**Year 1 Monitoring Report**

**LITTLE SEBASTIAN SITE**

NCDMS Project # 100027 (Contract # 7187) | RFP 16-006993 (Issued 9/16/2016)  
USACE Action ID: SAW-2017-01507 | DWR Project # 2017-1041

RE: Little Sebastian Mitigation Site: Year 1 Monitoring Report (NCDMS Project ID #100027)

### MY1 Little Sebastian BS1-E Stage Recorder

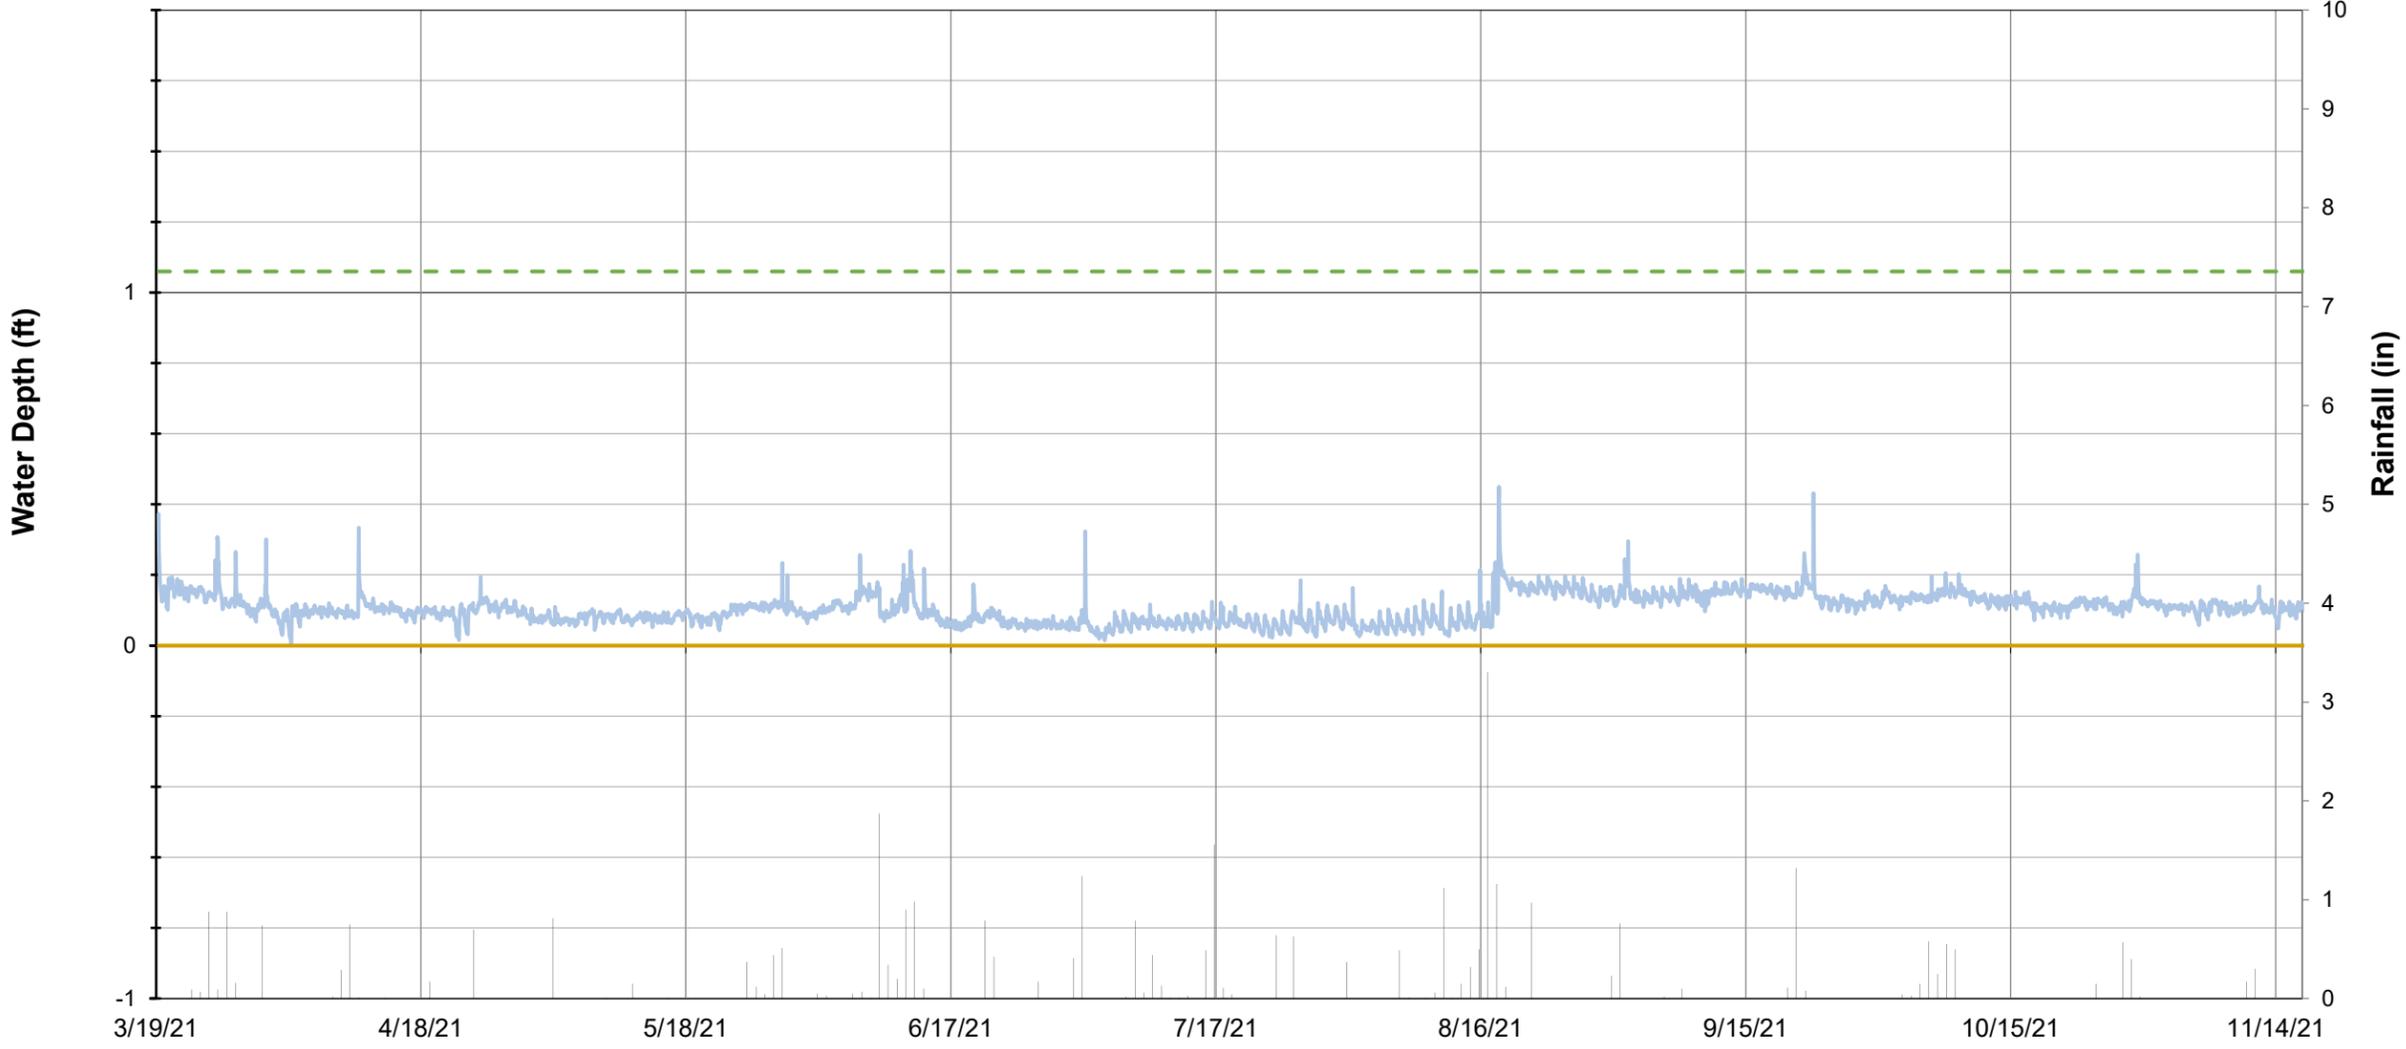
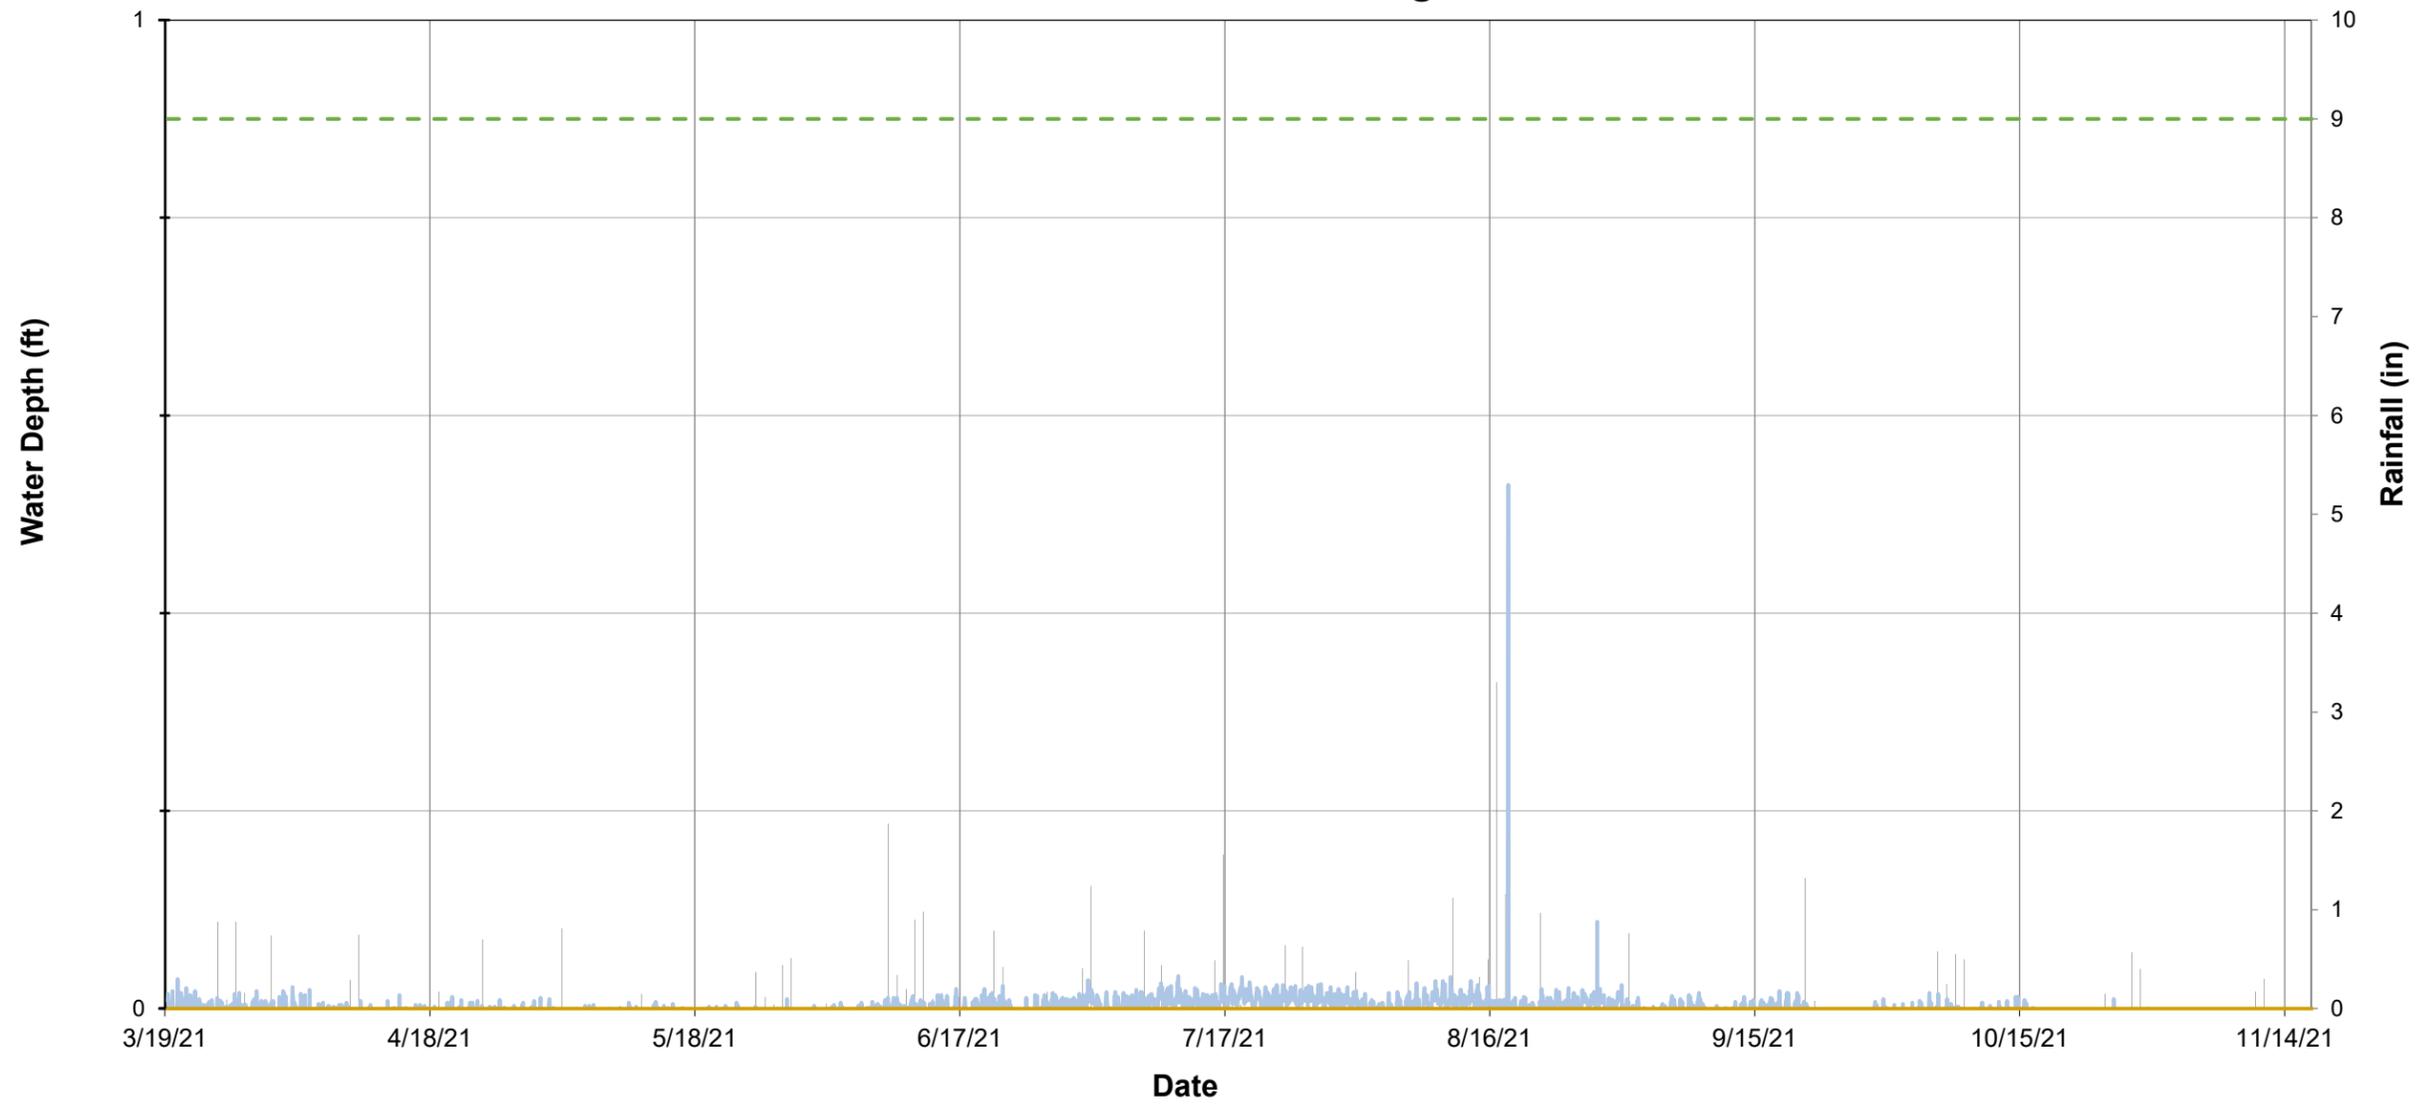
**Digital Support Files:** Please include figures displaying the data for overbank stage recorders JN3-B & BS1-E.

[Figures was added to \*\*Appendix E\*\* displaying the overbank data for the stage recorders. Please note, the stage recorder on JN3-B is installed with the sensor approximately 0.9 feet below the top of bank. All readings when the water level is below that elevation are inaccurate.](#)

# MY1 Little Sebastian GW1

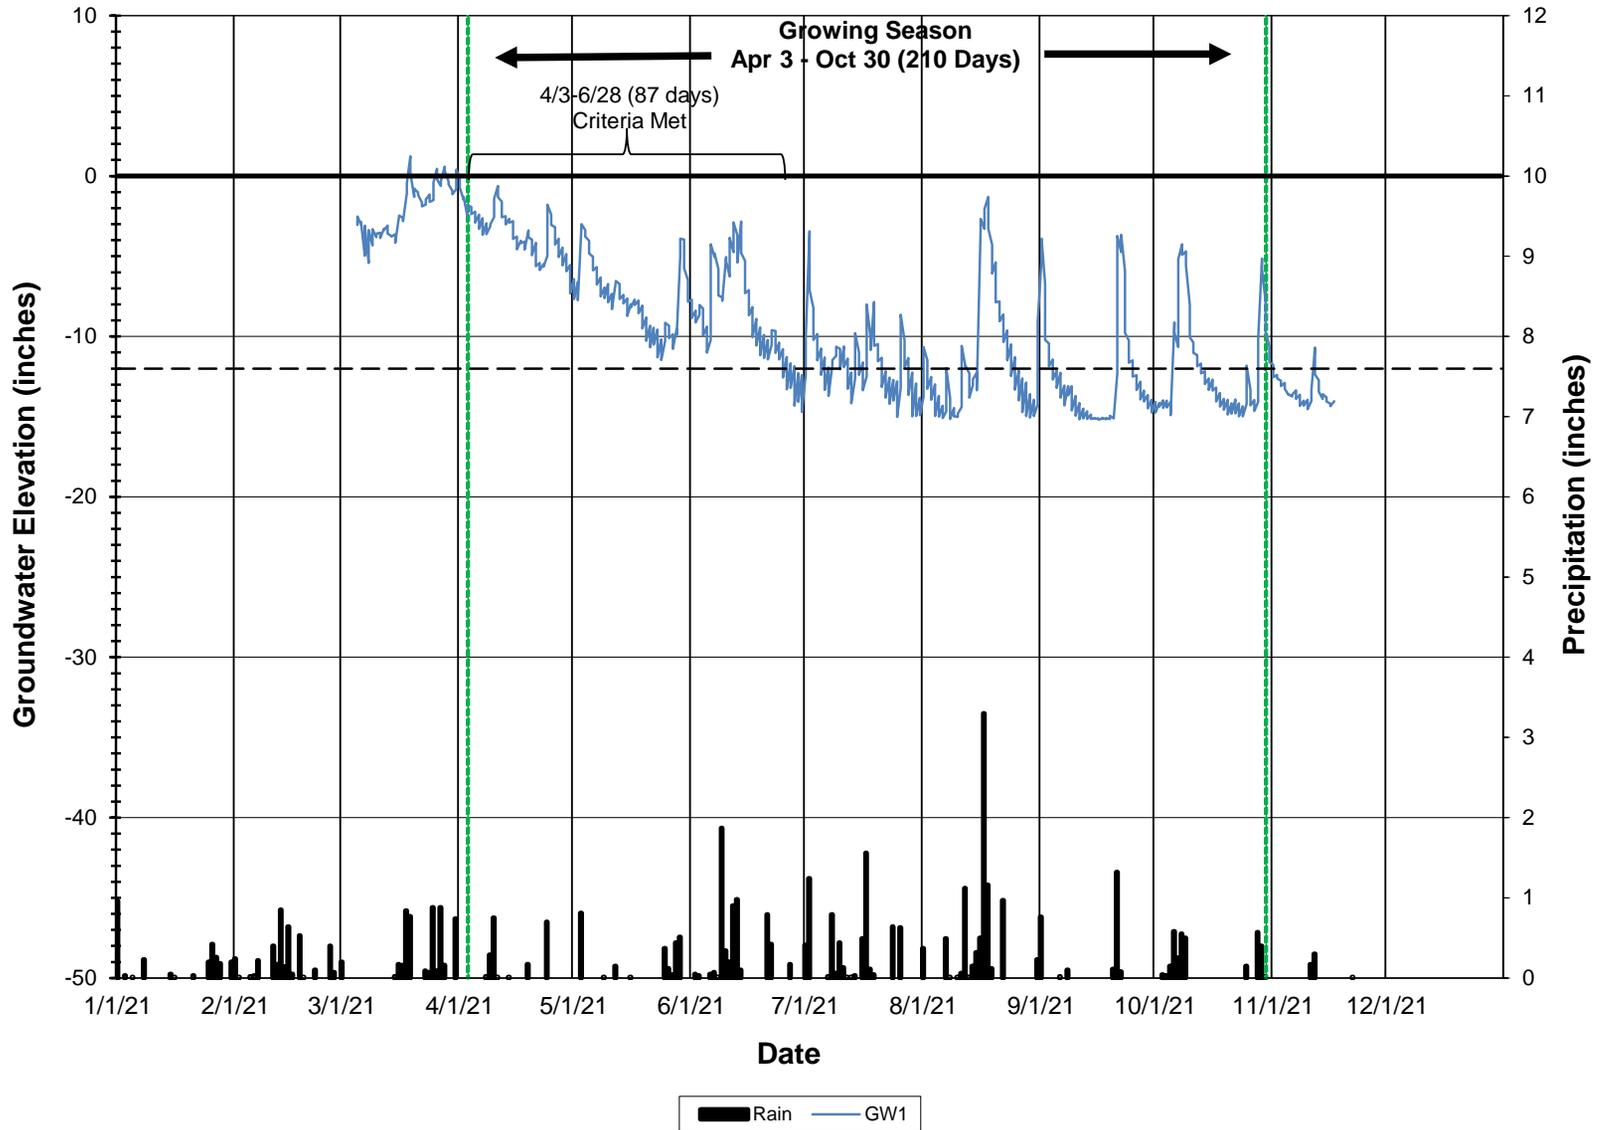
**Appendix E – Hydrology Data** (MY1 Little Sebastian GW1): In the graph, please point out the 87 consecutive days reported in Table 14.

[Maximum consecutive days have been added to both GW1 and GW2 graphs, found in \*\*Appendix E\*\*.](#)
